Access Compliance Report

Public Rights-of-Way

(Curb Ramps)

Intersection ID: 43227	Main Street: N_I-77_EXIT_5_RA	Cross Street: N_I-77_HY	Location: NW
ADA ID: 91D38E70EADE	Ramp Type: Perp	Initial Pass/Fail: Fail	Overall Compliance: No
Severity Score: 21.25			
Codes/Mitigation Info/Possible Solution		Field Measurements/Component Compliance

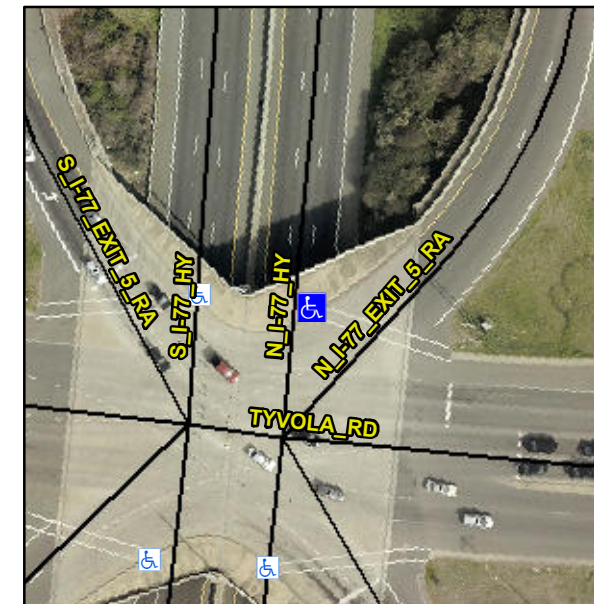
Not Found, R304.5.1, R304.2.2

Compliance	Description	Data	Compliance	Description	Data
N/A	Ramp Length (in)	86.0	No	Ramp Slope (%)	8.9
No	Ramp Width (in)	43.0	Yes	Ramp XSlope (%)	1.2
N/A	Flare Type LT	N/A	N/A	Flare Type RT	N/A
N/A	Flare Slope LT (%)	N/A	N/A	Flare Slope RT (%)	N/A
N/A	Flare Traversable LT?	N/A	N/A	Flare Traversable RT?	N/A
N/A	Landing Length (in)	N/A	N/A	DWS Provided?	N/A
N/A	Landing Width (in)	N/A	N/A	DWS Contrast?	N/A
N/A	Landing Slope (%)	N/A	N/A	DWS Length (in)	N/A
N/A	Landing X Slope (%)	N/A	N/A	DWS Full Width?	N/A
N/A	Landing Curb? (Y/N)	N/A	N/A	DWS Offset (in)	N/A
N/A	Shared Landing?	N/A			
N/A	Gutter Ponding?	N/A	N/A	Gutter Slope (%)	N/A
N/A	Gutter Lip Ht (in)	N/A	N/A	Gutter X Slope (%)	N/A
N/A	Painted X Walk1?	Yes	N/A	Painted X Walk2?	N/A
	X Walk 1 Direction	To SE		X Walk 2 Direction	N/A
N/A	X Walk 1 Width (in)	72.0	N/A	X Walk 2 Width (in)	N/A
	X Walk 1 Slope (%)	1.3		X Walk 2 Slope (%)	N/A
	X Walk 1 X Slope (%)	2.7		X Walk 2 X Slope (%)	N/A

Remove & Replace Entire Ramp.
